BRANZ REPORT

FD1882/CF02/1

REPORT ON COMPLIANCE OF A FACADE SYSTEM AT 12 SELWYN ROAD,
COCKLE BAY, AUCKLAND WITH NZBC FIRE SAFETY CLAUSES

Figure 2 TS110 exposed fastener system

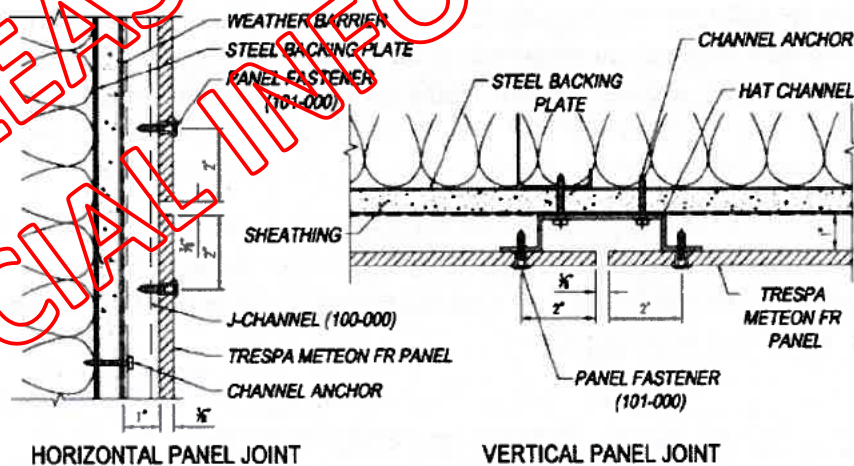
Fixing Trespa Meteon FR wall panels to the substructure with aluminium rivets rather than steel screws would most probably cause more panels to fall, or panels to fall sooner than for the case where steel screws have been used. This change does not improve or maintain the performance of the system compared to that in the fire test. While it might not result in increased flaming above the windows opening, it is

generally undesirable behaviour increasing the hazard of falling materials onto fire fighters or others located below. Depending on the combustibility of the panels, there is also the possibility of fire spread if the panels are flaming when they fall. It is however noted that the NZBC does not specifically address this type of failure mode of non-structural panels.

I note that increasing the spacing of the fixings is not likely to improve the performance of the system compared to that in the fire test. It is not really known if the performance would be maintained or not.

Figure 3 Extract from James Hardie Specification JHETGR60a

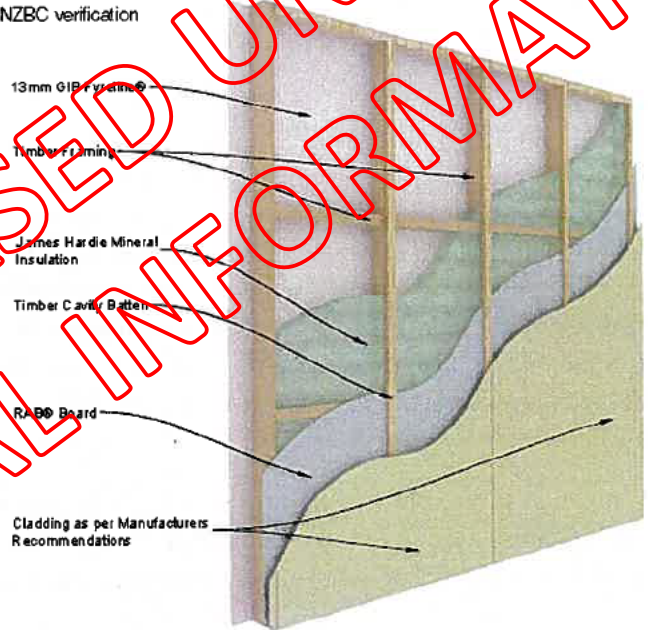
The applicant now proposes to upgrade the base wall to a James Hardie JHETGR60a wall with an FRR 60/60/60 fire rating. This is an external wall assembly with a fire rating achieved from both sides separately constructed as shown in Figure 3. The timber cavity battens and outer cladding are to be replaced with the aluminium framework supporting the Trespa FR panels. Additionally, it is proposed to install a layer of 13 mm thick Fyrelite gypsum plasterboard between the RAB and the timber framing on the exterior side. The applicant also proposes to replace the previously proposed aluminium rivet fixings with 5.0mm stainless steel blind rivets with a 16mm head and 304 stainless steel mandrel with fixing centres as per the NFPA 285 tested system.

The BRANZ fire test report FR2494 from which the JHETGR60a specification was derived provided observations about the behaviour of a 6.0 mm thick Villaboard and a 7.5 mm thick Harditex board fixed to a timber frame and directly exposed to the furnace gases in a fire resistance test. It stated that at 10.5 minutes there was a 3 mm crack in the Villaboard and at 20 minutes, the Harditex had a 5 mm wide crack with flaming coming from the timber stud behind. These observations are made from a viewing port into the furnace so that the face exposed to the furnace gases can be

seen. I would expect the proposed 6.0 mm thick RAB proposed to be used in the wall at 12 Selwyn Road would perform no better than either of these boards.

Fire resistance ratings are determined based on limiting the temperature and spread of flames/gases reaching the unexposed side of the wall. Consideration of conditions within the cavity and the possible involvement of combustible materials in the cavity is not part of the required performance criteria in a standard fire resistance test. However, observations in the fire resistance test indicated that neither 6.0 mm thick Villaboard nor 7.5 mm thick Harditex board are sufficiently thick/robust to prevent flame entry into the wall cavity. I would surmise that 6.0 mm thick RAB board would also not be sufficient. To address this concern, the applicant proposes to add a layer of 13 mm thick Fyrelite gypsum plasterboard between the RAB and the timber framing.

I have reviewed the proposed exterior wall assembly as described in the Maynard Marks letter of 25 October 2017 which now includes installing a layer of 13 mm Fyrelite gypsum plasterboard between the timber framing and RAB of the base wall assembly. The applicant also agrees to use 5.0 mm stainless steel blind rivets with a 16mm head and 304 stainless steel mandrel with fixing centres as per the NFPA 285 tested system.

With these changes, I am satisfied that the exterior wall system now proposed for installation at 12 Selwyn Road, Auckland would most likely pass the NFPA 285 fire test.
